GASCOYNE HOLDINGS LIMITED

COLE GREEN LANDFILL

EXPERT REPORT

OCTOBER 2017

Figure 2-1 Environment Agency Map of Historic Landfills Across Site Area

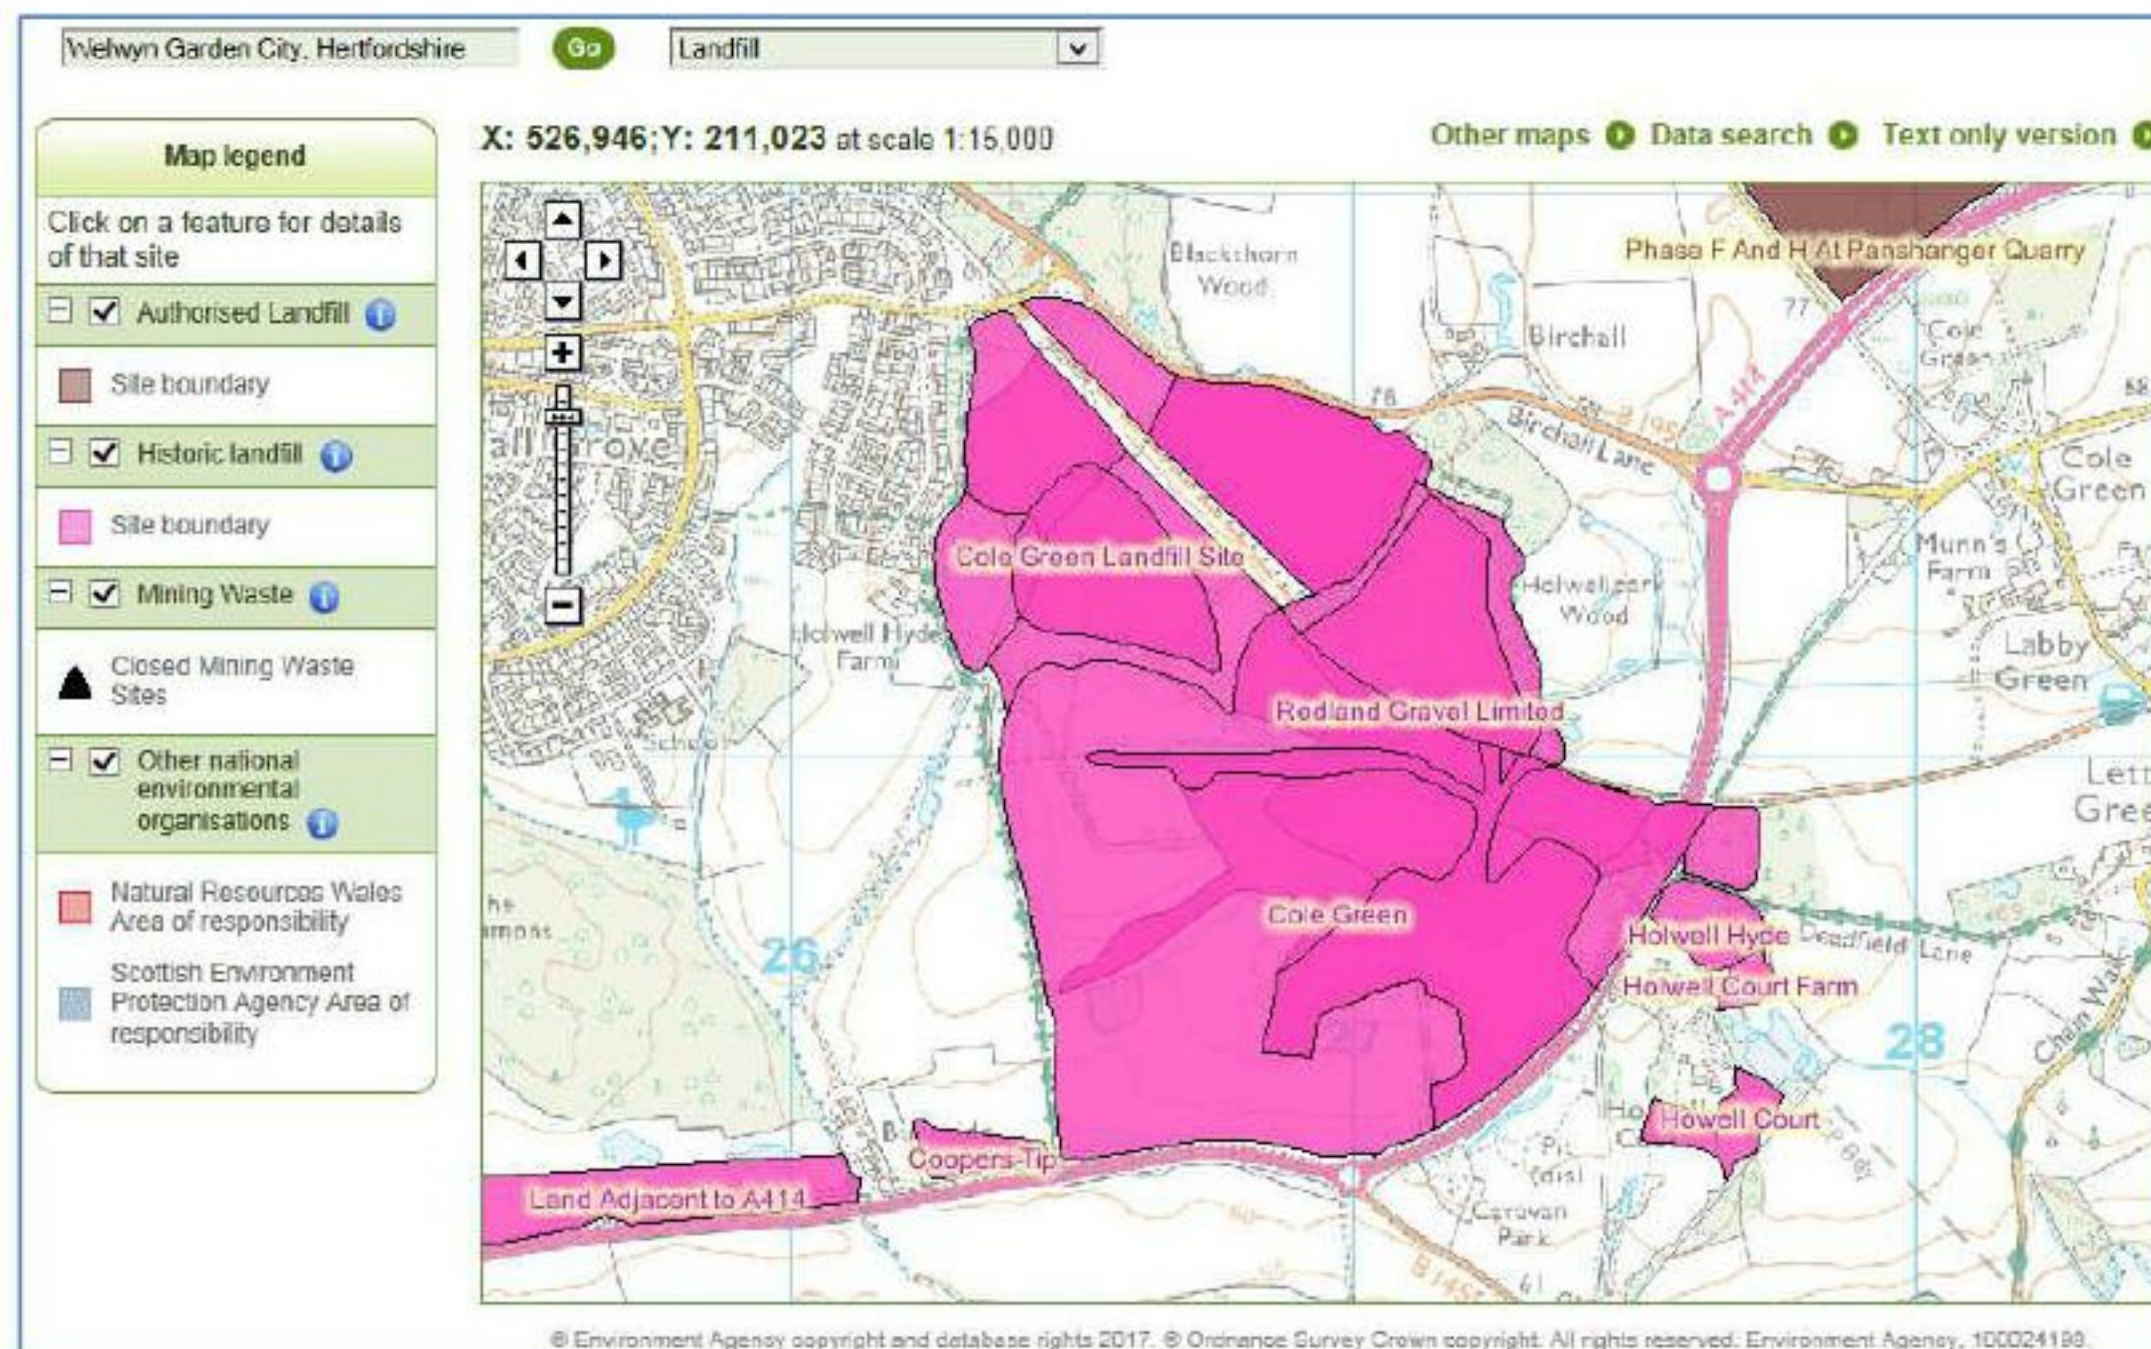
2.3.3 We have consulted the Environment Agency's map of historic landfill sites which suggests the following areas as having been used for waste disposal.

- 2.3.4 It is considered that the southern area of the site as identified by the EA marries up with The Welwyn Garden City Society (WGCS)'s opinion but conflicts with RHDHV's understanding that it has no history of landfilling.
- 2.3.5 The WGCS produced an updated report '*What Lies Beneath*' in November 2016 which offers opinion on the potential contamination of land within WGC5. We note that WGCS's references the whole site as WGC5 however RHDHV's report only refers to the western and southern areas as WGC5. WGCS's report provides the plan below and photos purporting to be of the site. We have no reason to doubt the accuracy of the photo locations however we accept that they are estimated.

- 2.4.6 Given the EA and WGCS maps in Figures 2-1 and 2-2 above it is considered that the scope and extent of the site investigation in the southern part of the site should be reviewed by a contaminated land expert to determine if it remains appropriate. [Note: a review has subsequently been undertaken Chris Smith, Technical Director. Please see section 3]

Figure 2-4 Area of Land Subject to Investigation

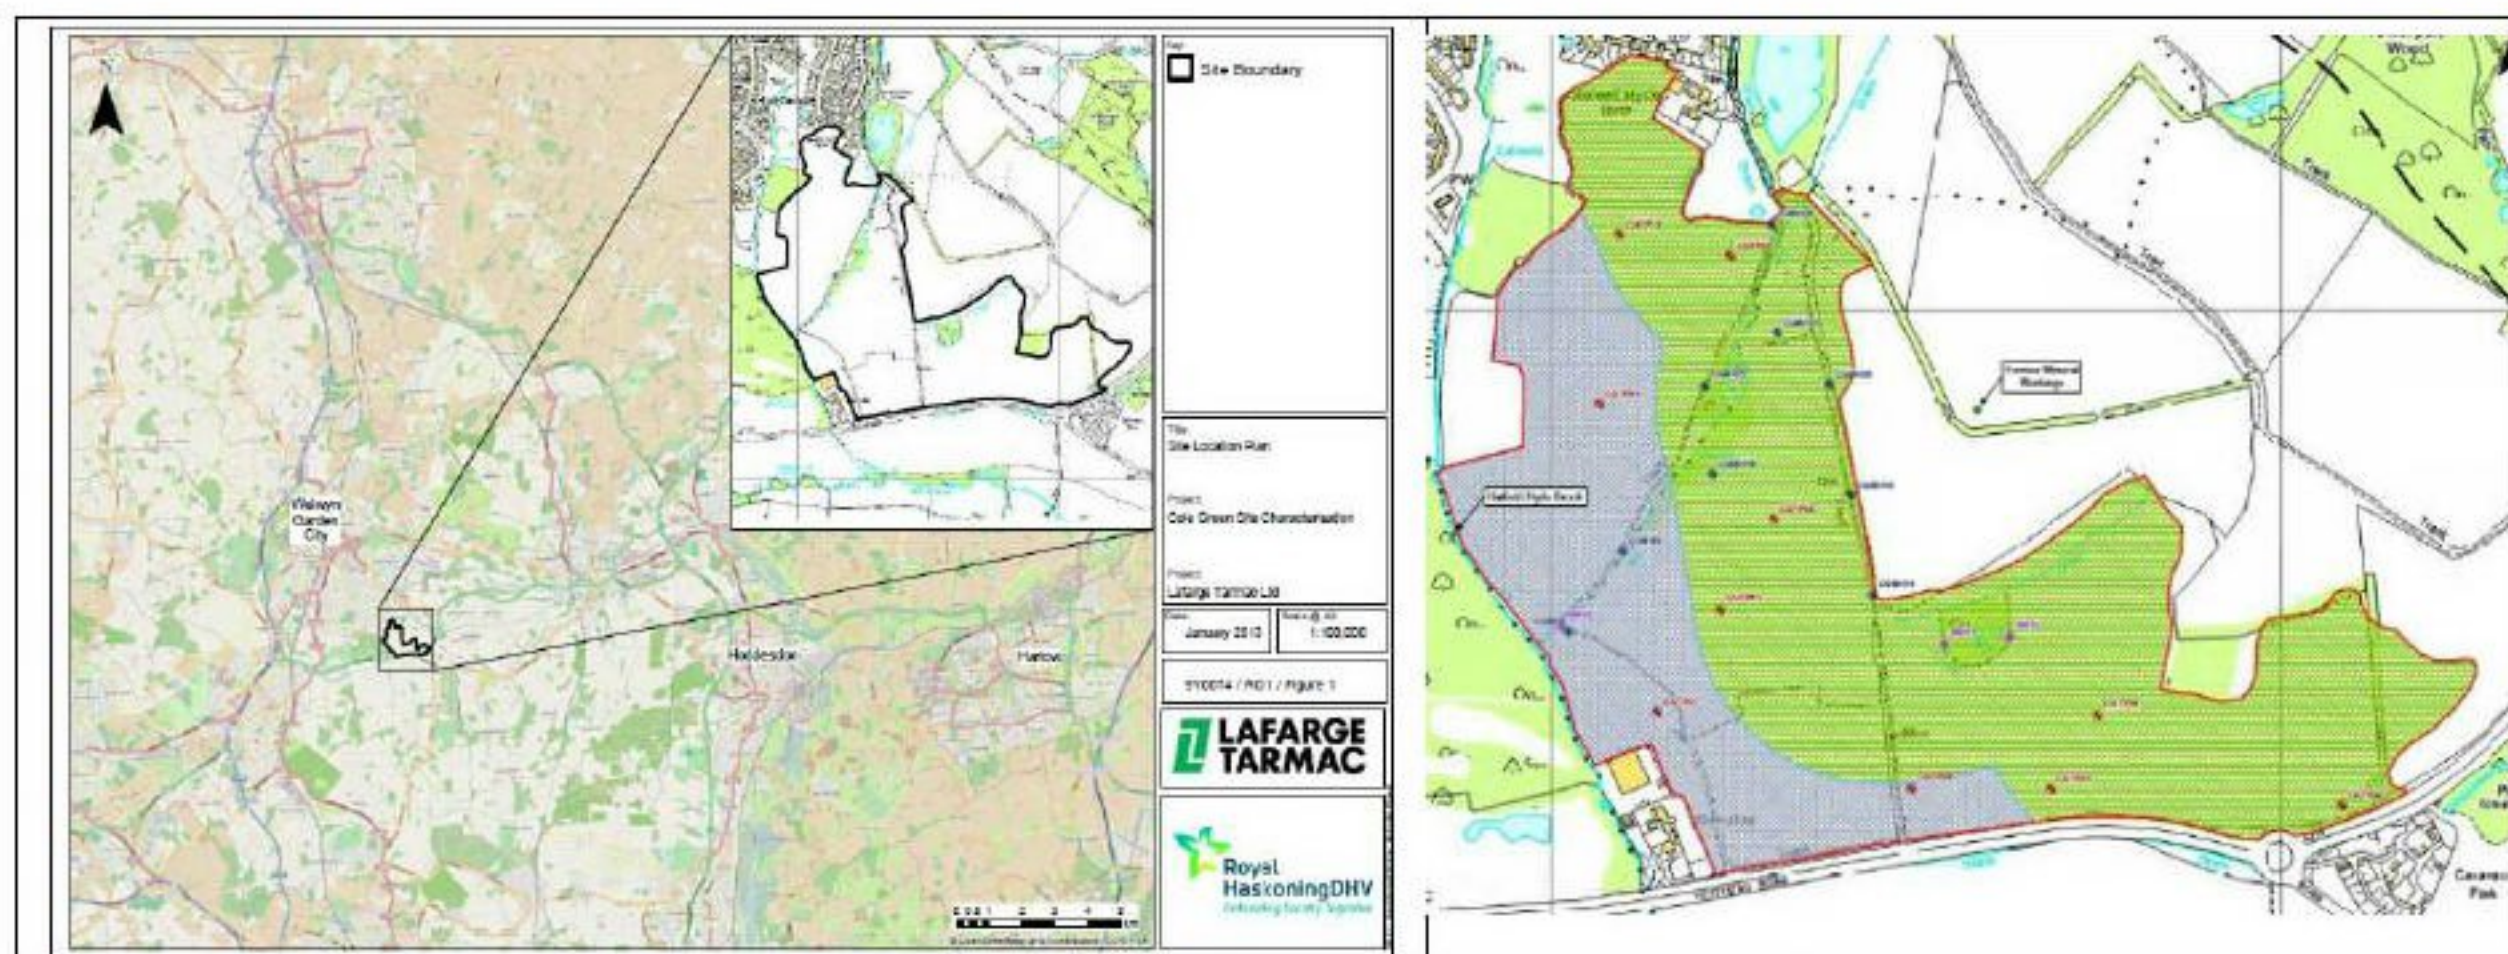
- 2.4.3 We note that this report was produced as a result of previous reports, copies of which we have not been provided with. We also note that works planned for January 2014 were delayed until May 2014 after this report was issued.
- 2.4.4 Findings of the report include comments that made ground was encountered and this contained asbestos and hydrocarbons. This would suggest this area has had wastes spread across it to produce a uniform landform.
- 2.4.5 The report acknowledges that surface water quality is a possible (unacceptable) risk to human health. The main finding is that engineering solutions are required at the site however no commentary is provided on the type or extent of these.

Figure 2-5 Area of Land Subject to Investigation

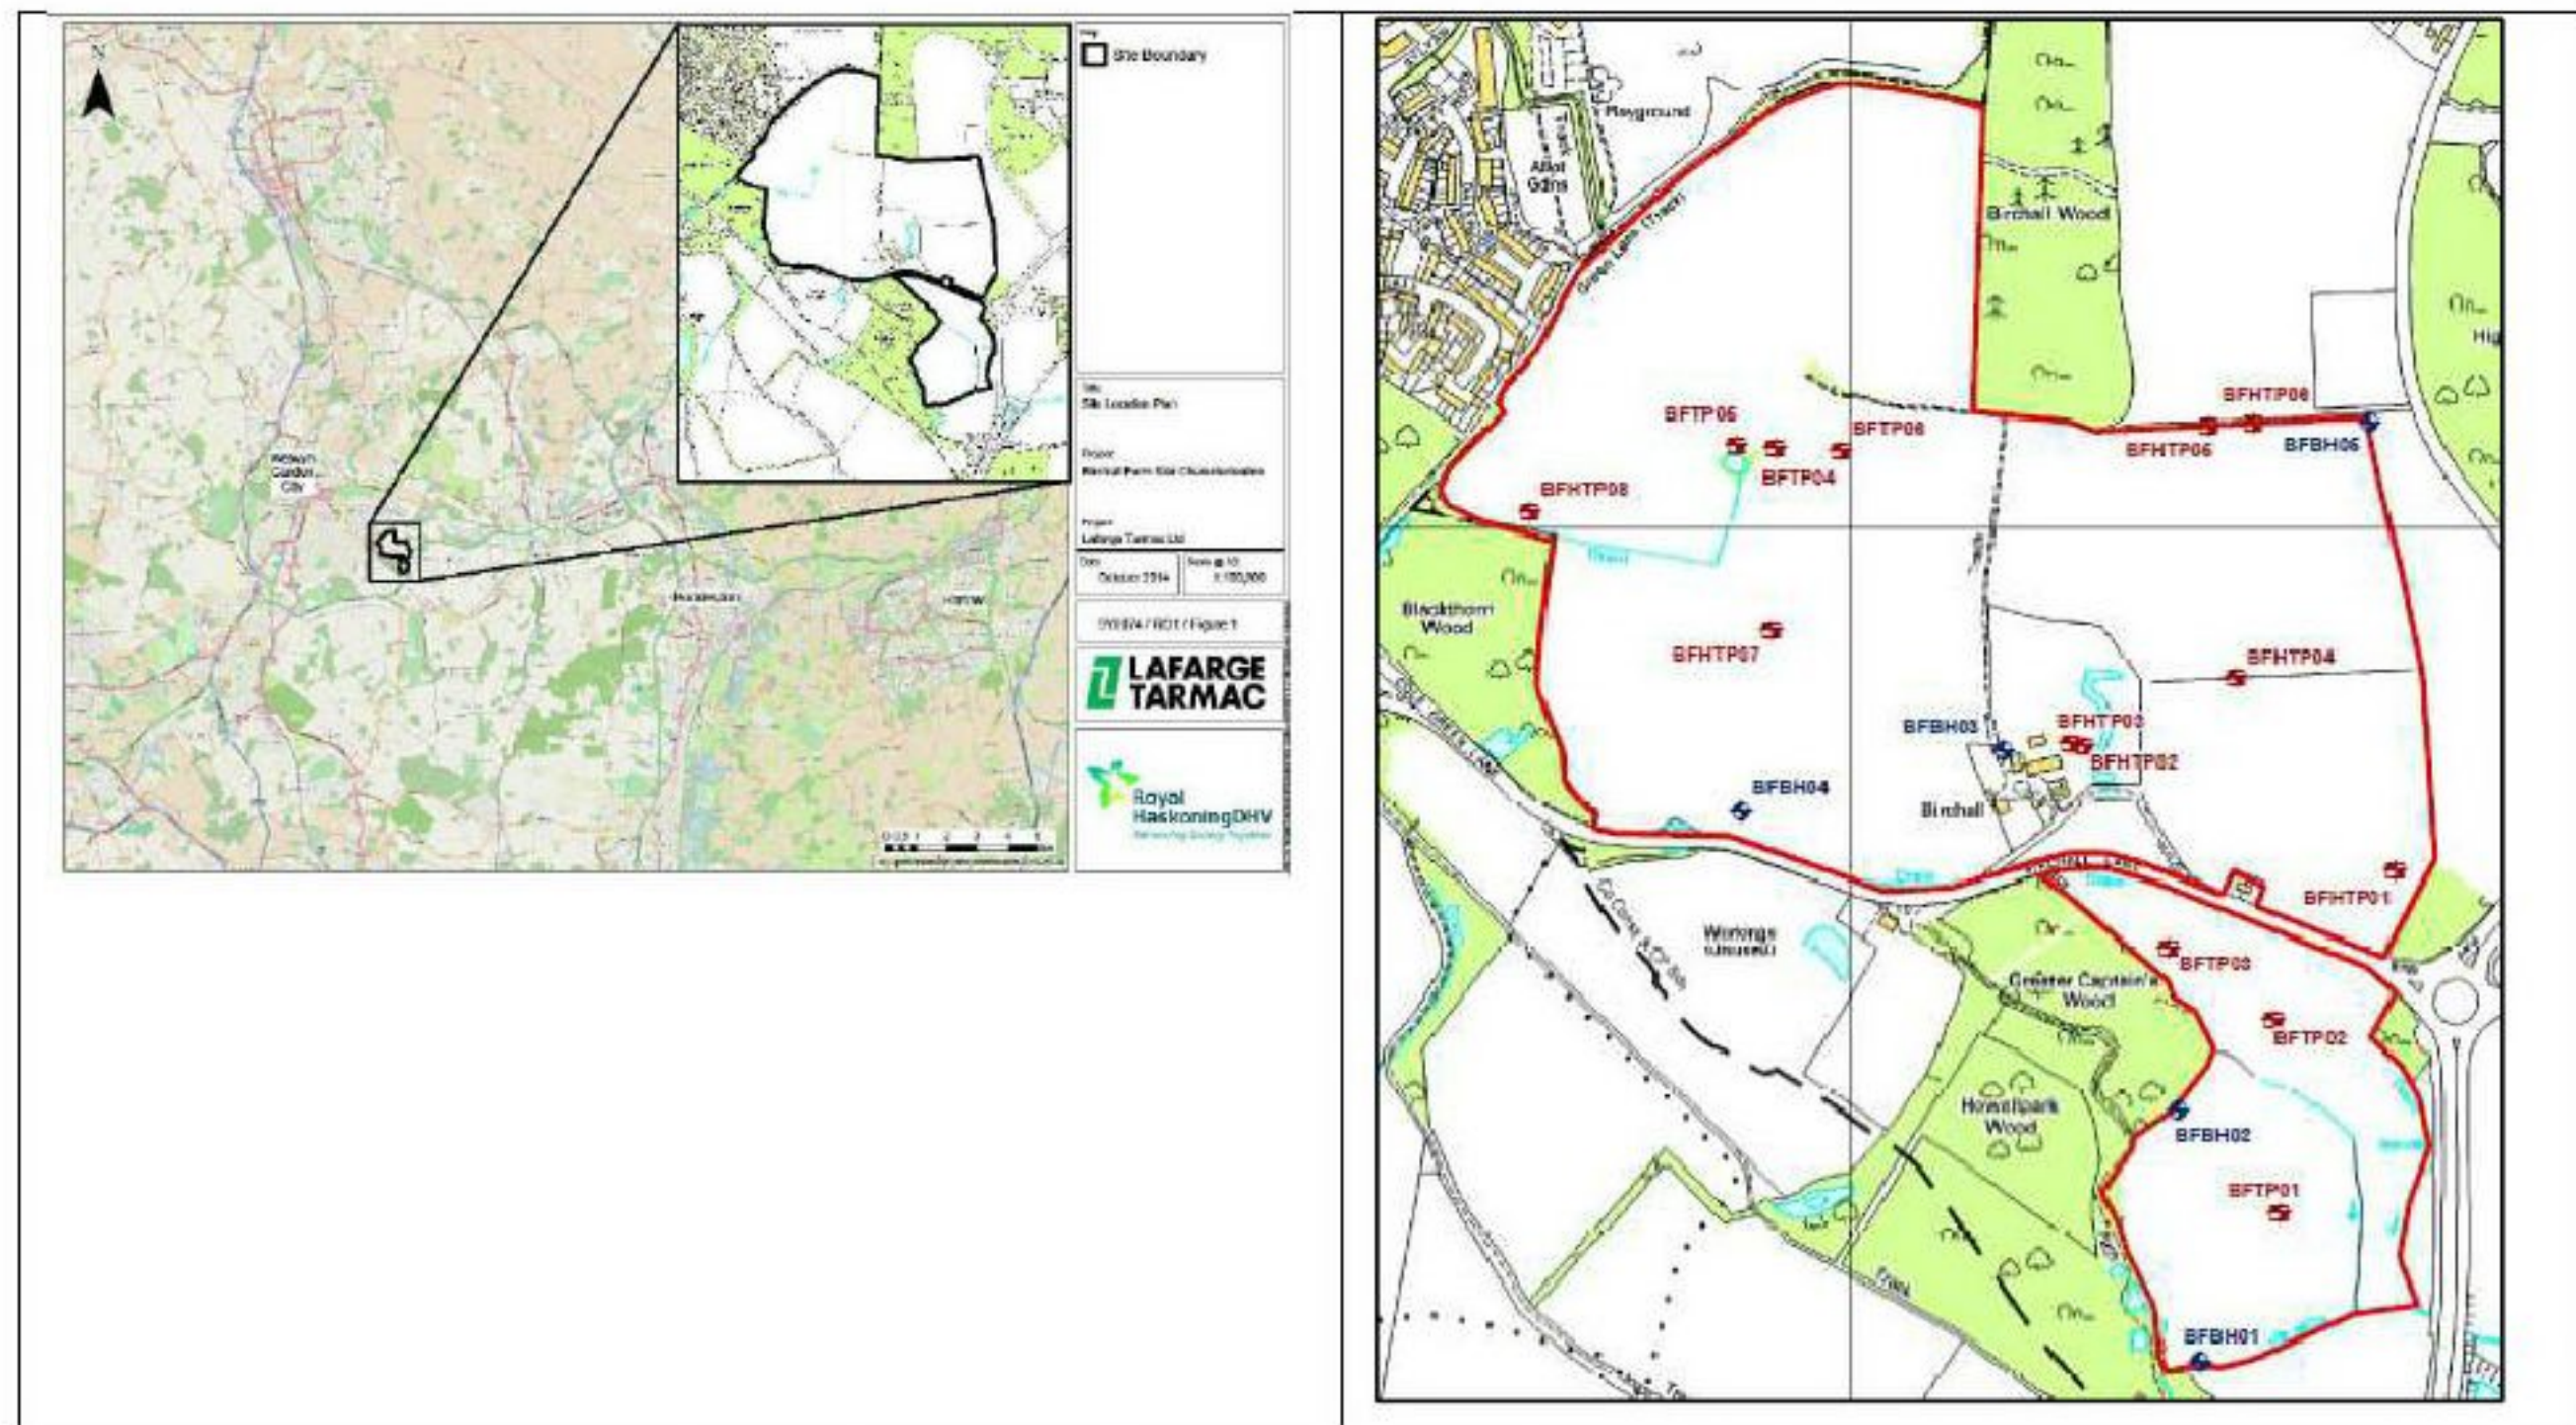
2.4.13 The Executive Summary plays down the materials found but concludes that PCOC found on site at levels harmful to human health which require some excavation and removal from site.

2.4.14 The report also confirms a medium level risk from unexploded ordnance.

2.4.15 The main finding is that engineering solutions are required at the site however no commentary is provided on the type or extent of these.
